GOVERNMENT OF THE DISTRICT OF COLUMBIA  
DEPARTMENT OF TRANSPORTATION

**MEMORANDUM**

**SUBJECT:** ZC Case No. 16-13 – 1109 Congress Street, NE

Figure 1: Site Design and Access (Source: Gorove/Slade)

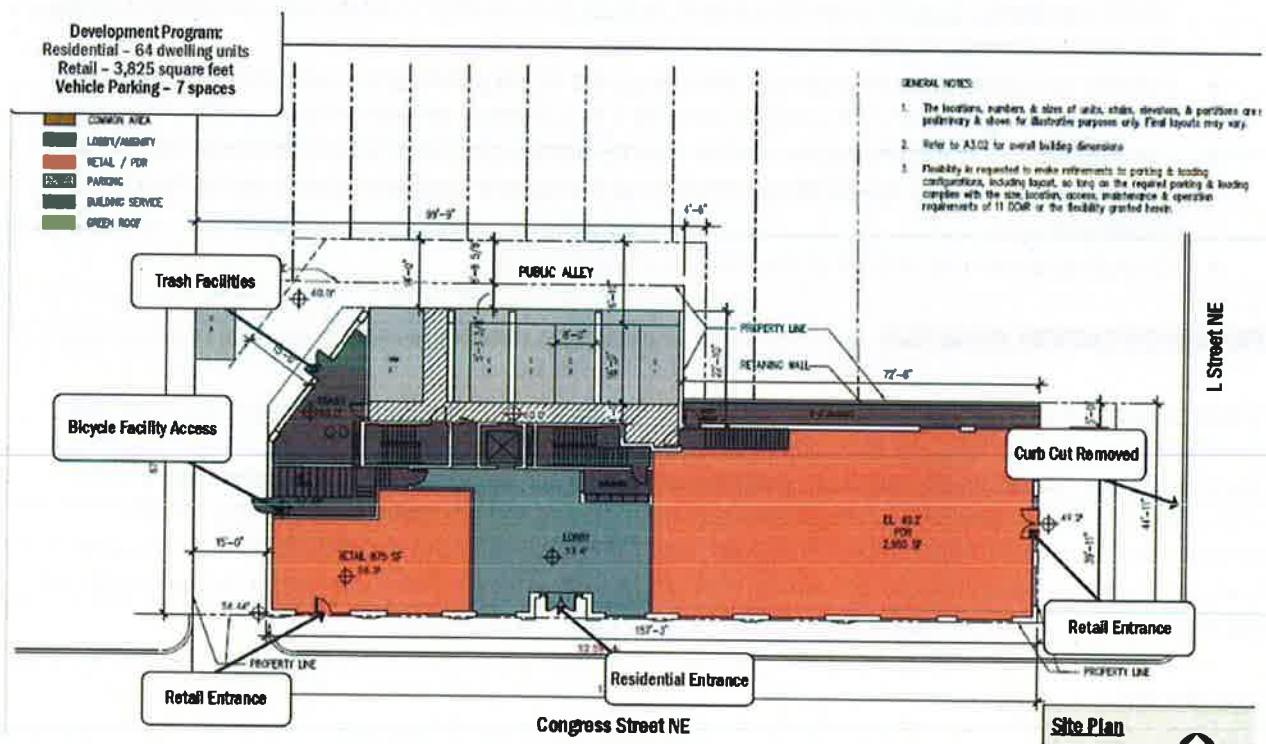
The existing 9 foot public alley that runs east-west from Congress Street through the middle of the site is proposed to be closed. In turn, the Applicant proposes a new private connection to the 8 foot 6 inch north-south public alley east of the site through a 15 foot wide easement at the north of the site. Vehicular and bicycle access is proposed via this alley easement.

The Applicant proposes to setback the ground floor adjacent to the north-south public alley by 5 feet 3 inches in order to provide vehicle parking. Due to the design of the vehicle parking spaces, DDOT requested turning analysis of all vehicle parking spaces in order to determine whether the design of the parking spaces would result in back-out maneuvers onto Congress Street. Due to vehicle, pedestrian, and bicycle conflicts, DDOT will not support vehicles to back-out onto the street. The Applicant conducted a vehicle turning analysis, as requested and submitted on November 14, 2016 to DDOT. The analysis showed that all of the vehicle parking spaces are designed for front-in and front-out maneuvers on Congress Street. Due to the necessity of multiple point turns to adequately clear all obstructions, such as columns, all vehicle parking spaces should be reserved for compact vehicles in order to properly maneuver. The Applicant proposed six of the seven vehicle parking spaces as compact spaces, which is appropriate.

Zoning requires one 55-foot loading berth, one 200 square foot platform, and one 20-foot service and delivery space. The Applicant does not propose any on-site loading and requests zoning relief. Instead, the Applicant proposes curbside loading from Congress Street for residential moves and trash pick-up and curbside loading from L Street for retail deliveries. The proposed residential loading and trash pick-up will result in either back-out maneuvers from the alley easement onto Congress Street as trucks turn around on this dead-end street or back-out maneuvers from Congress Street onto L Street. DDOT does not support trucks backing out of either the alley easement or Congress Street due to safety concerns regarding vehicle, pedestrian, and bicycle conflicts.

While DDOT does not object to loading relief, a loading management plan, which includes a flagger, is necessary for all trucks accessing the site from Congress Street, including residential move-ins, move-outs, and trash collection due to back-out maneuvers. Additionally, as a part of the public space permitting process, an updated parking signage plan is necessary in order to remove parking where truck sweeps coincide with on-street vehicle parking and loading spaces.

In particular, the Applicant proposes a utility vault within the alley easement. It is DDOT's understanding that PEPCO maintenance vehicles need a minimum 20 feet wide and 40 feet of vertical clearance in order to access and maintain utility vaults. The proposed alley easement is 15 feet wide. As such, the building footprint may need a minor modification if PEPCO cannot support the vault within the 15 foot alley easement. DDOT will not support utility vaults in public space at this location, in part, because District of Columbia Municipal Regulations Title 12A, Section 3202.7.1.1 does not permit any projections other than cornices, bases, sills, belt courses, pilaster, and water tables beyond the building line on streets that are less than 60 feet in width. Congress Street is 40 feet wide.
